# Eltham Urban Congestion Fund Project

Consultation Summary

September 2021

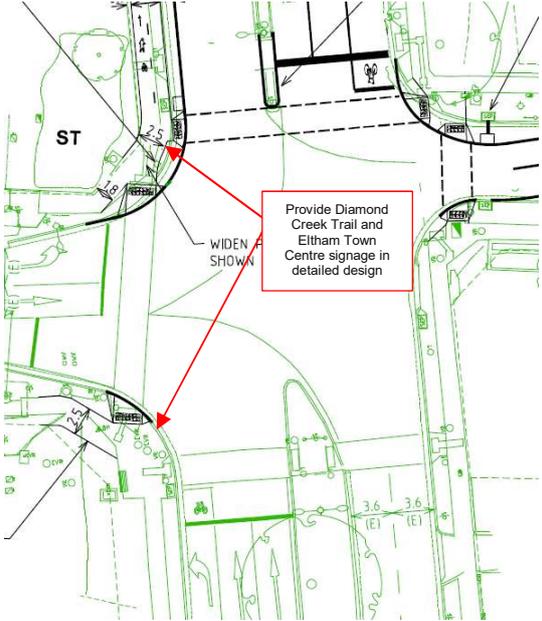
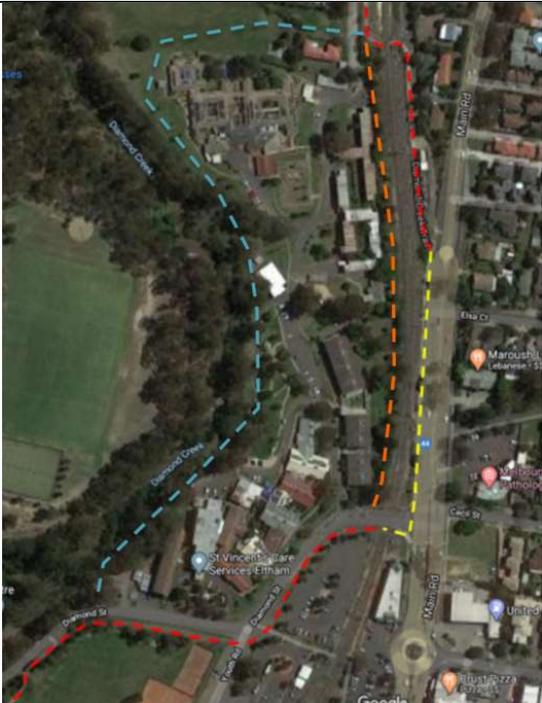
Description of change	Illustration of change
Adopt <b>Option 2</b> : Construction of a 2.5m-wide shared path with underground power lines.	n/a
Modify Drawing No. V191990-01-01 Sheet 1 of 13 issue P1 (undergrounded power line option) to include green pavement treatment of the Diamond Creek Trail where it crosses Diamond Street.	
Modify Drawing No. V191990-01-01 Sheet 1 of 13 issue P1 (undergrounded power line option) to include Diamond Creek Trail priority movement, rumble street treatments and sightline improvements on the approach to Main Road.

Description of change	Illustration of change
<p>Modify Drawing No. V191990-01-01 Sheet 1 of 13 issue P1 (undergrounded power line option) to include a footpath connection from the Diamond Creek Trail to the commuter car park on Diamond Street.</p>	
<p>Modify Drawing No. V191990-01-02 Sheet 2 of 13 issue P1 (undergrounded power line option) to include Diamond Creek Trail and Eltham town Centre signage in detailed design.</p>	
<p>Initiate a discussion with St Vincent's Health and VicTrack on a longer-term 'missing link' to the Diamond Creek Trail either along the Diamond Creek (requiring St Vincent's private landholdings) or the western side of the railway (requiring VicTrack agreement).</p>

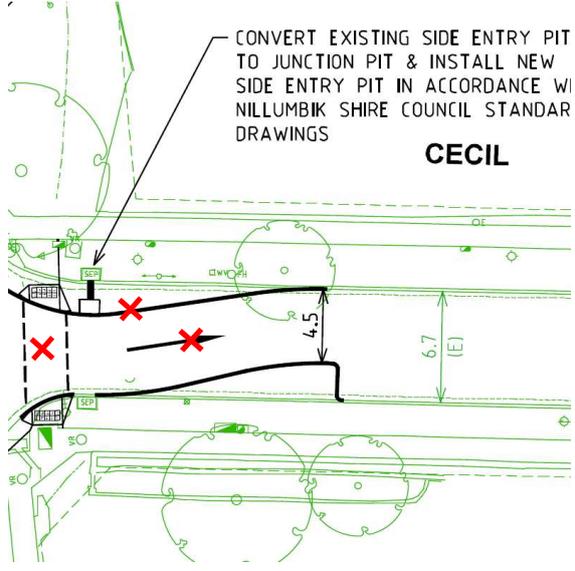
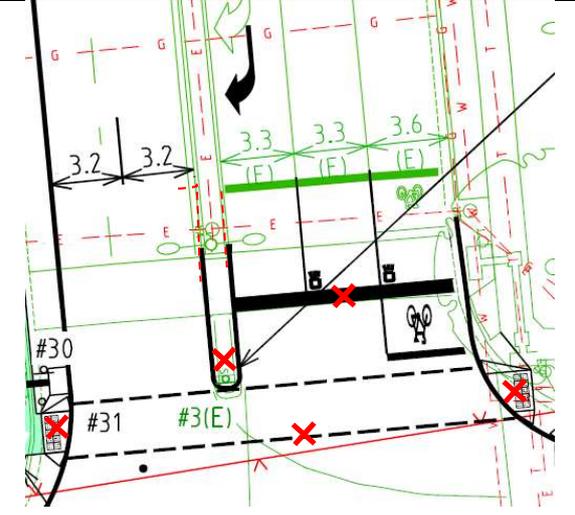
Description of change	Illustration of change
<p>Abandon proposal to make Cecil Street 'entry only' from Main Road as part of the Urban Congestion Fund and retain existing pedestrian crossing conditions (further investigation as a separate project).</p>	
<p>Modify Drawing No. V191990-01-02 Sheet 2 of 13 issue P1 to remove the proposed Cecil Street 'entry only' treatment from Main Road and retain existing pedestrian crossing locations and kerblines (retain existing conditions).</p>	 <p>CONVERT EXISTING SIDE ENTRY PIT TO JUNCTION PIT &amp; INSTALL NEW SIDE ENTRY PIT IN ACCORDANCE WITH NILLUMBIK SHIRE COUNCIL STANDARD DRAWINGS</p> <p><b>CECIL</b></p> <p>The drawing shows a plan view of Cecil Street with several pits. A callout line points to a specific pit with the text above. Dimensions are shown: 4.5m for a pit width, and 6.7m (E) for a distance. Red 'X' marks indicate locations where existing conditions are to be retained.</p>

<p>Modify Drawing No. V191990-01-02 Sheet 2 of 13 issue P1 to remove the proposed pedestrian crossing and stop line relocation on Bible Street, the proposed central island extension and pram crossing relocations (retain existing conditions).</p>	 <p>The drawing shows a plan view of Bible Street with various markings. Dimensions include 3.2m, 3.3m (F), 3.3m (F), and 3.6m (E). Red 'X' marks indicate locations where existing conditions are to be retained. Labels #30, #31, and #3(E) are present.</p>

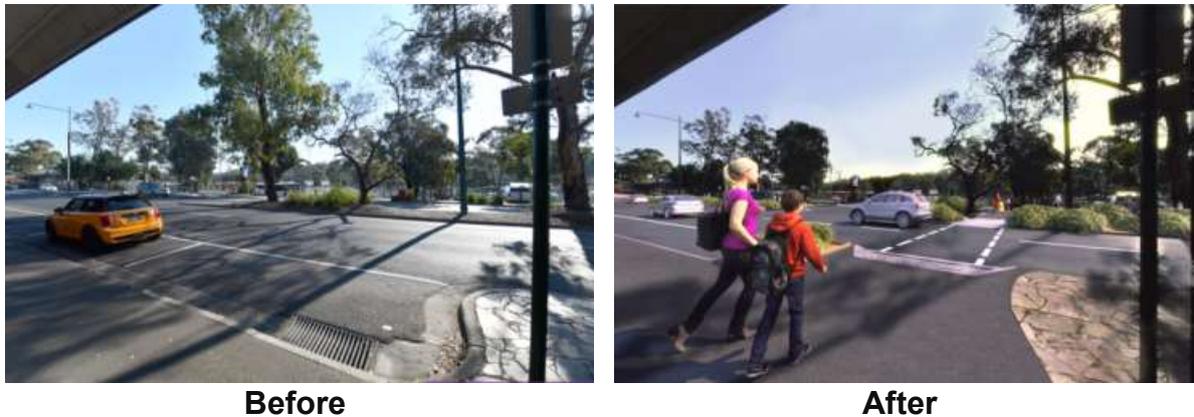
Description of change	Illustration of change
<p>Modify Drawing No. V191990-01-03 Sheet 3 of 13 issue F1 to correct the 'Parking Area 1P Ticket' sign on the signage schedule (#29) that is in use on Car park on the west of the Luck Street roundabout which is 'Parking Area 1P'.</p>	<p>#29</p>

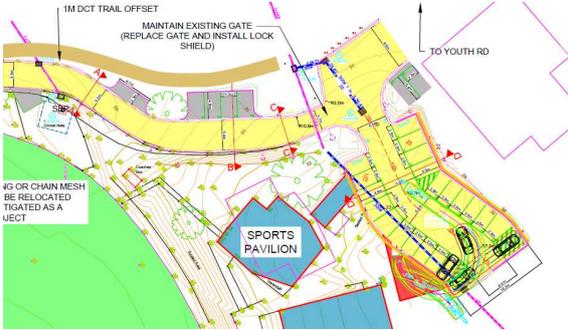
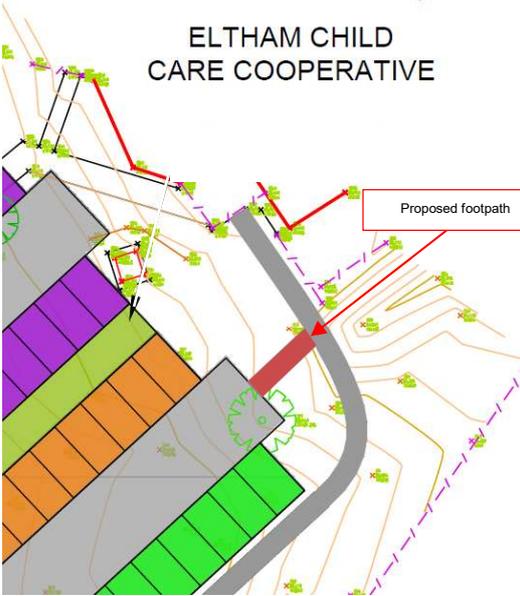
Description of change	Illustration of change
<p>Modify Eltham Central Oval Functional Layout Plan to include barrier kerb along the rear of the proposed Eltham Central Oval car parking.</p>	
<p>Modify Eltham Central Oval Functional Layout Plan to include the Youth Road/Panther Place gate at the existing location but with a new gate with a vandal-proof cover over a new lock.</p>	
<p>Modify Eltham Central Oval Functional Layout Plan to include a landscaping plan for the Eltham Central Oval, including new large canopy trees where possible.</p>

Description of change	Illustration of change
<p>Modify Eltham Central Oval Functional Layout Plan to include parking delineation around the western wing of Eltham Central Oval to use reflectors or 't' linemarking to minimise visual impact.</p>	
<p>Modify Eltham Central Oval Functional Layout Plan to include car park layout plan prepared for the Eltham Central Pavilion works (refer JCA Land Surveyors DWG no. 25426, dated 25/6/2020).</p>	
<p>Council is currently reviewing parking restrictions at Eltham Central Oval.</p>	
<p>Council is currently installing bike racks at the Eltham Central Oval Pavilion.</p>	
<p>Modify Eltham Central Oval Functional Layout Plan to include a footpath from the car park to the Child Care Co-Op.</p>

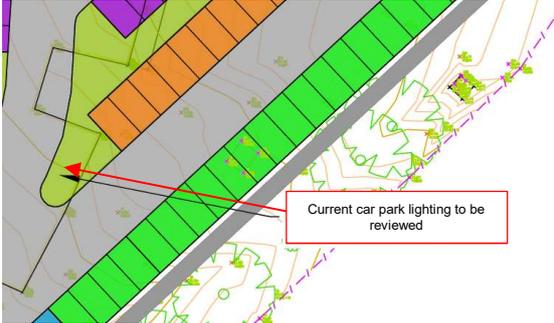
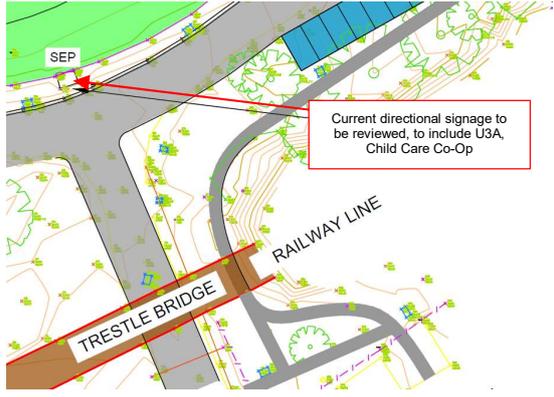
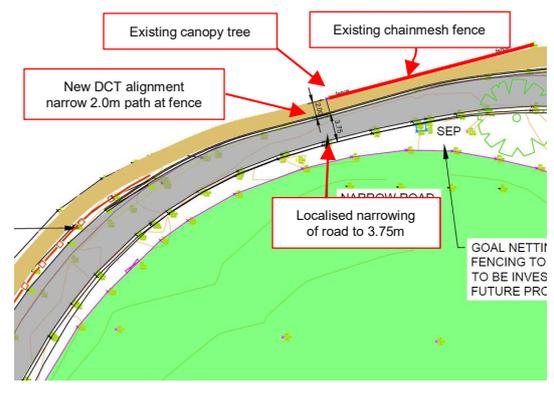
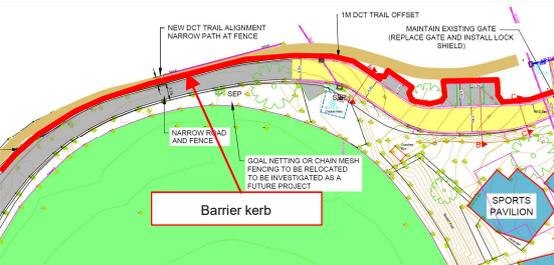
Description of change	Illustration of change
<p>Modify Eltham Central Oval Functional Layout Plan to include consideration of lighting.</p>	 <p>Current car park lighting to be reviewed</p>
<p>Modify Eltham Central Oval Functional Layout Plan to include consideration of directional signage to the U3A, Child Care Co-Op and Eltham Central Oval.</p>	 <p>Current directional signage to be reviewed, to include U3A, Child Care Co-Op</p> <p>TRESTLE BRIDGE</p> <p>RAILWAY LINE</p>
<p>Modify Eltham Central Oval Functional Layout Plan to include notation on the plan 'Goal netting or chainmesh fence to be relocated between the roadway and the black boundary fence (to be investigated and funded as a separate project)'.</p>	 <p>Goal netting or chainmesh fence to be relocated between the roadway and the black boundary fence (to be investigated and funded as a separate project)</p> <p>NARROW ROAD AND FENCE</p> <p>SEP</p>

<p>Modify Eltham Central Oval Functional Layout Plan to include realignment of the proposed Diamond Creek Trail to avoid the vegetation impacts of locating it behind the existing chain mesh fence.</p>	 <p>Existing canopy tree</p> <p>Existing chainmesh fence</p> <p>New DCT alignment narrow 2.0m path at fence</p> <p>Localised narrowing of road to 3.75m</p> <p>GOAL NETTING FENCING TO BE INVESTIGATED AS A FUTURE PROJECT</p> <p>NARROW ROAD</p> <p>SEP</p>
<p>Modify Eltham Central Oval Functional Layout Plan to include barrier kerbing along the Diamond Creek trail through the area behind the Eltham Central Oval goal posts as vehicle drivers occasionally inadvertently drive up the Diamond Creek Trail.</p>	 <p>Barrier kerb</p> <p>NEW DCT TRAIL ALIGNMENT NARROW PATH AT FENCE</p> <p>1M DCT TRAIL OFFSET</p> <p>MAINTAIN EXISTING GATE (REPLACE GATE AND INSTALL LOOK SHIELD)</p> <p>NARROW ROAD AND FENCE</p> <p>GOAL NETTING OR CHAIN MESH FENCING TO BE RELOCATED TO BE INVESTIGATED AS A FUTURE PROJECT</p> <p>SPORTS PAVILION</p>

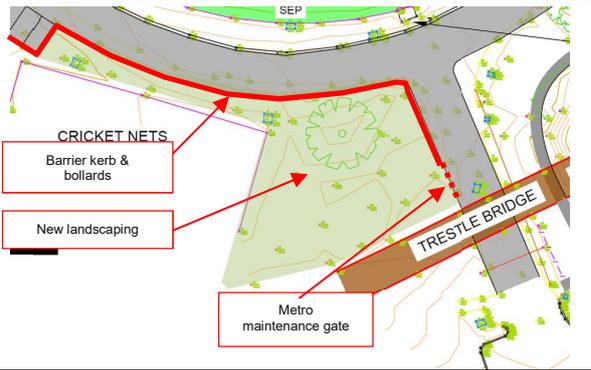
Description of change	Illustration of change
<p>Modify Eltham Central Oval Functional Layout Plan to include barrier kerbing and bollards to protect the large tree near the trestle bridge from vehicle parking and create an opportunity for landscaping.</p>	 <p>The illustration shows a site plan of Eltham Central Oval. A red line outlines a new barrier kerb and bollards area surrounding a large tree. Labels with arrows point to 'CRICKET NETS', 'Barrier kerb &amp; bollards', 'New landscaping', and 'Metro maintenance gate'. A 'TRESTLE BRIDGE' is also labeled on the plan.</p>
